Re: Fort Lauderdale Consent Order OGC No. 16-1487
Consent Order Project 6(h): Force Main Condition Assessment (FMCA)
FMCA Report Comments Response Letter

The City of Fort Lauderdale (City) acknowledges receipt of comments dated May 4, 2020 by the Florida Department of Environmental Protection (FDEP) on the Force Main Condition Assessment Report submitted on March 23, 2020. The purpose of this letter is to respond to the five comments issued.

Figure 1

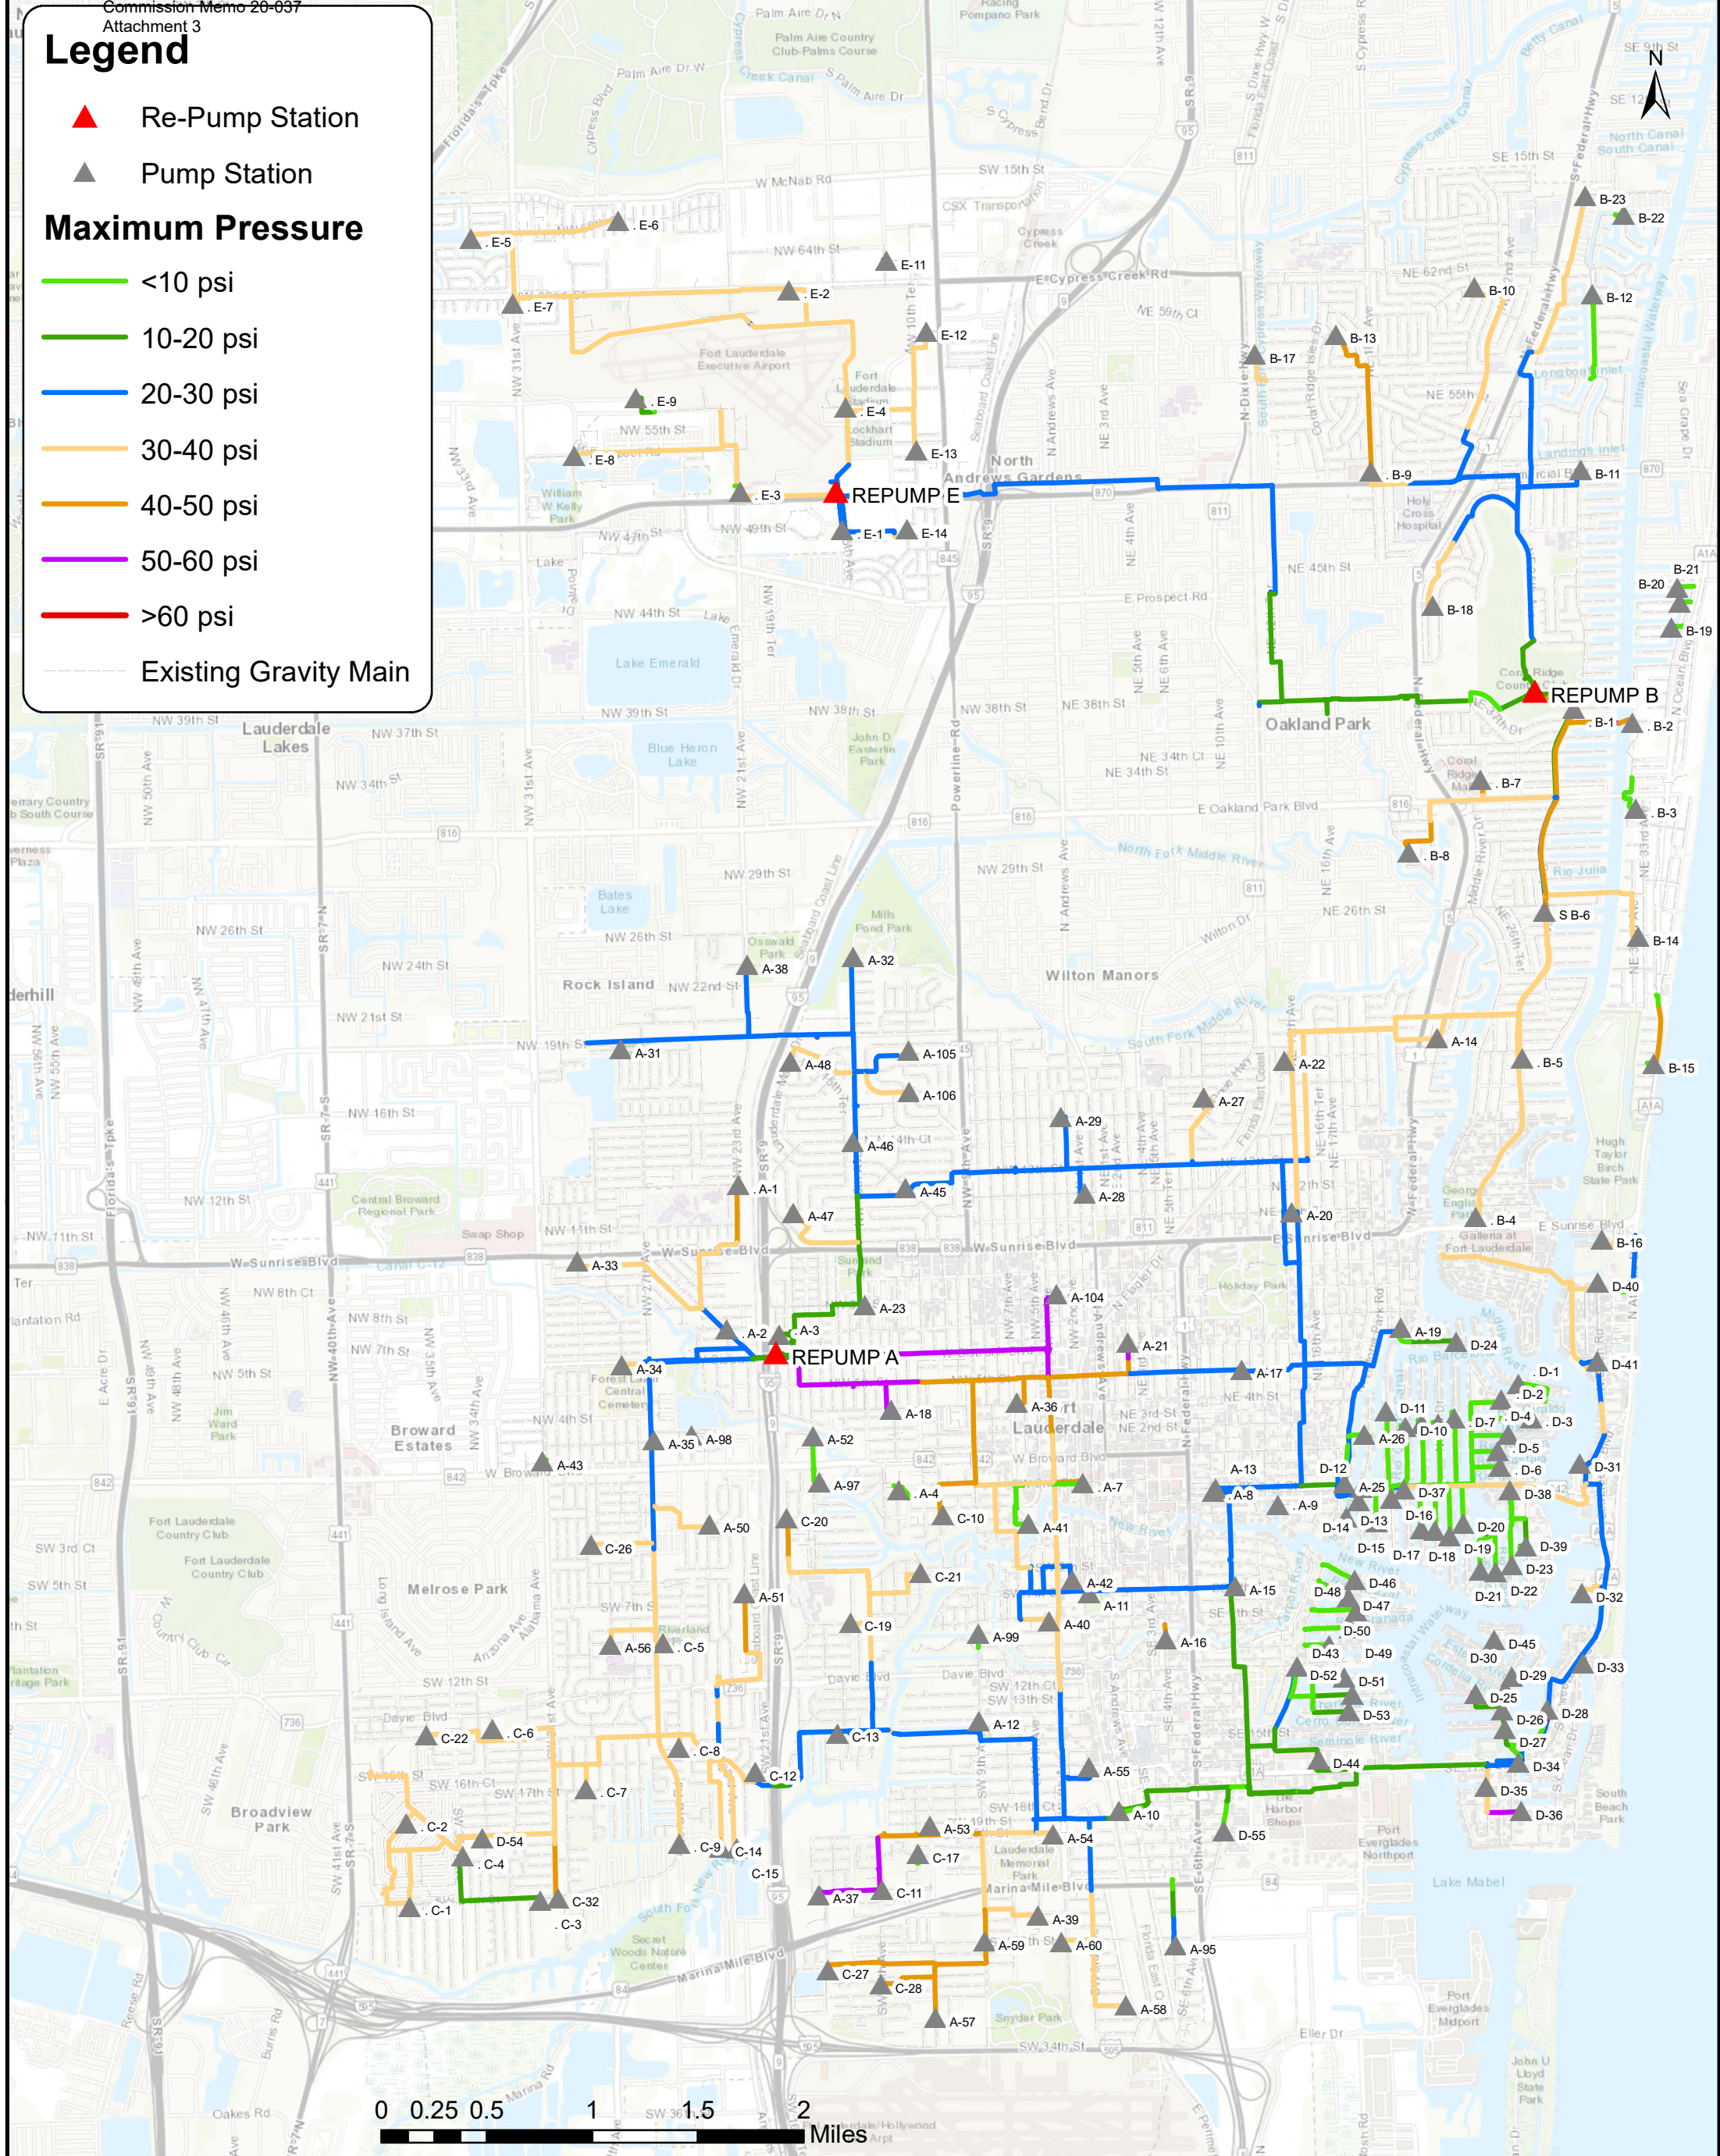
FDEP Comment No. 5 – There should be a table with all the FM segments that have maximum FM operating pressures over 60 psi. The table should list the actual maximum FM pressures. Excessive pressure might require additional FMs or increased sized FMs to correct the problem.

City Response to Comment No. 5: The attached Figure 1 depicts the maximum pressure in the City's force main system under year 2021 wet weather flow scenario. As shown, there are no areas with pressures over 60 psi. Although there are some areas with pressures within 50 – 60 psi, the City is planning to mitigate these areas through future capital improvement projects that will address these areas and provide systemwide redundancy. This Figure will also be included FMCA report to be reissued.
